Verification Report of Boomitra Grassland Restoration in Northern Mexico

Document Prepared by 4K Earth Science Private Limited

Report ID	25009-VCS-VER
Project title	Boomitra Grassland Restoration in Northern Mexico
Project ID	2887
Verification period	04/09/2018 to 03/09/2022
Original date of issue	23/05/2025
Most recent date of issue	16/02/2026
Version	7

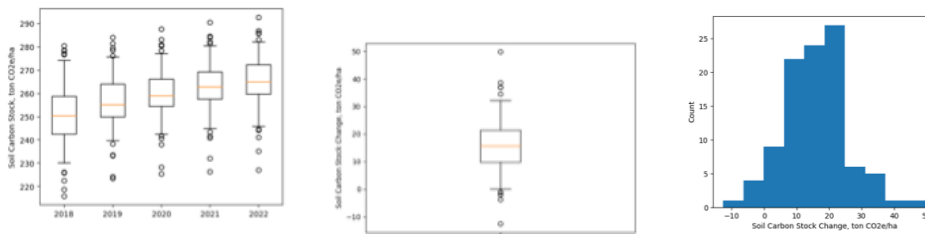
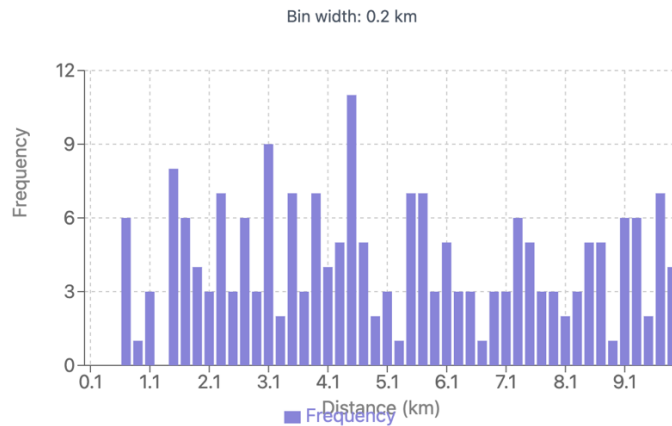
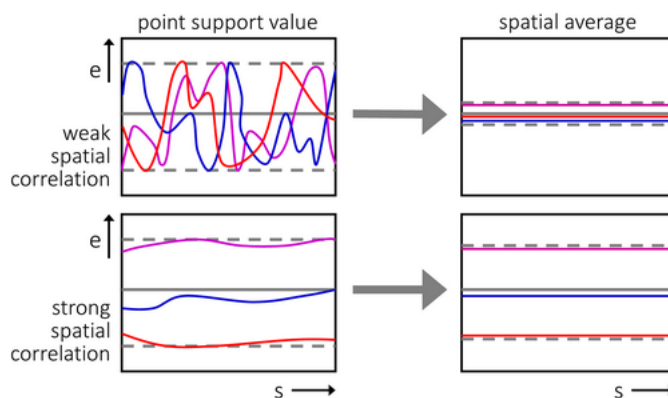
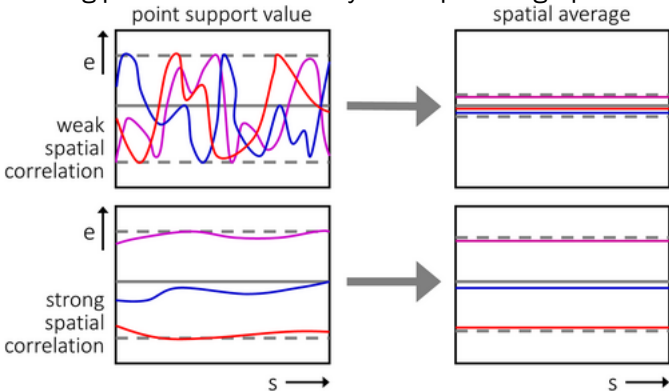
CAR ID	26	Section no.	Mexico SOC Remote Sensing Technical Summary	Date:	02/05/2025
Description of CAR					
The Model's Uncertainty: - Clarify whether the Monte Carlo method uses predicted SOC stock values, observed values, or both. - Explain how spatial autocorrelation was accounted for (e.g., include a semi variogram example) and how pixel-level PPDs are aggregated to derive ranch-level PPD. - Explain how temporal correlations were incorporated into the Monte Carlo approach. Was any time-series modelling or dependency structure incorporated?

CAR ID	26	Section no.	Mexico SOC Remote Sensing Summary	Technical	Date:	02/05/2025
4. Provide the equations for each step in Figure 13. Provide a detailed breakdown of the methodology, specifying the formulas (e.g., simplified equations to illustrate the steps) and statistical techniques applied. The presentation of steps that do not belong to the proposed method (e.g., RothC) confuses the reader. 5. Specify the soil depth used in the example calculation.						
Project participant response					Date :	10/05/2025

1. The uncertainty propagation uses the prediction errors of the SOC stock values on the validation dataset, meaning that it uses both the prediction for the validation dataset and the observed value, as their difference is the prediction error. To model the Predictive Posterior Distribution, as indicated in the text, N predictions of the model are made by varying the training of the model through Bayesian simulation. Then, the PPDs are corrected with the semi variogram built on the prediction errors, which brings in the aspect of spatial autocorrelation in the underlying real SOC distribution and allows the validation prediction errors to be accounted for in the uncertainty. 2. Pixel-level PPDs are aggregated to ranch level through simple averaging of all pixels within a given ranch for each simulation. It is equivalent to the SOC stock aggregation method given in the previous section. A semi variogram is produced for the residuals of the model with respect to the validation dataset. Thus, this semi variogram enables the simulation of spatially correlated residuals, which are then added onto the predictions produced by the model in a given simulation of the Bayesian MC process. In general, the semivariogram is given by: $\gamma(h) = \frac{1}{2} \times \text{Var}[Z(x) - Z(x + h)]$ Where: $\gamma(h)$ is the semivariance at distance (lag) h $Z(x)$ is the value of the variable at location x $Z(x + h)$ is the value at a location h units away $\text{Var}[\]$ denotes the variance Here is a semi variogram of the validation dataset in our case, with a spherical fit:

Observe that the 2018 and 2022 PPDs have a prediction interval that has a ± 20 tonCO₂e/ha (± 5 tonC/ha) half width. On the other hand, the change PPD, upon subtraction of 2018 and 2022, has a half-width of ± 15 ton CO₂e/ha (± 4 tonC/ha). This decrease from 2 distributions of ± 5 tonC/ha to one distribution of ± 4 tonC/ha is due to these systematic biases that occur across time (eg. in both 2018 and 2022) canceling out and shrinking the distribution.

- It is true that the quality of the Kriging is highly dependent on the density of the input data. However, it is not about regions with sparse-coverage versus those with denser coverage. It is more about having a sufficient number of observation that have pairwise distances that are close to one-another, in addition to those that are very far of away from one another, to fit the semivariogram. Note that we use a single semivariogram for a given ML model's residuals – we don't create a different semivariogram for each area within the project. The key challenge for us is to ensure that the semivariogram, which ultimately determines the Kriging weights and thus the Krigged residuals at each point, is of sufficient quality. This is achieved by having a sufficient number of pairwise distances in the validation data that are close to one another in addition to far from one-another. Typically, the challenge is not in having points far from one another but rather points that are close enough to allow for an accurate calculation of the range and nugget of the semivariogram.

You can see in the response above that the semivariogram here has a range of ~ 10 km. We have 202 pairwise distances in the validation data of less than 10km in our data, shown in the histogram below:

Now, you may be wondering what hypothetically happens when we need to simulate a residual for 2 given pixels and both are next to each other but really far away from the validation points (thus, an area with 'sparse coverage'). We can show that this results in a conservative overestimation of the ranch-level variance and thus the total uncertainty. Assuming that the semivariogram is of sufficient quality, as outlined by the check above, we have kriging weights generated for the known points, but given the 2 pixels are near each other but far from the known points, they will have very similar simulated residuals from the kriging. Thus, when they undergo averaging during the computation of the ranch-level average, the simulated residual does not help to reduce the variance in the ranch-level average. This can be seen in the figure from Wadoux et al.

The situation of 2 pixels near each other but far away from the validation points leads to an erring on the side of strong spatial correlation, leading to the spatial average to have a larger variance.
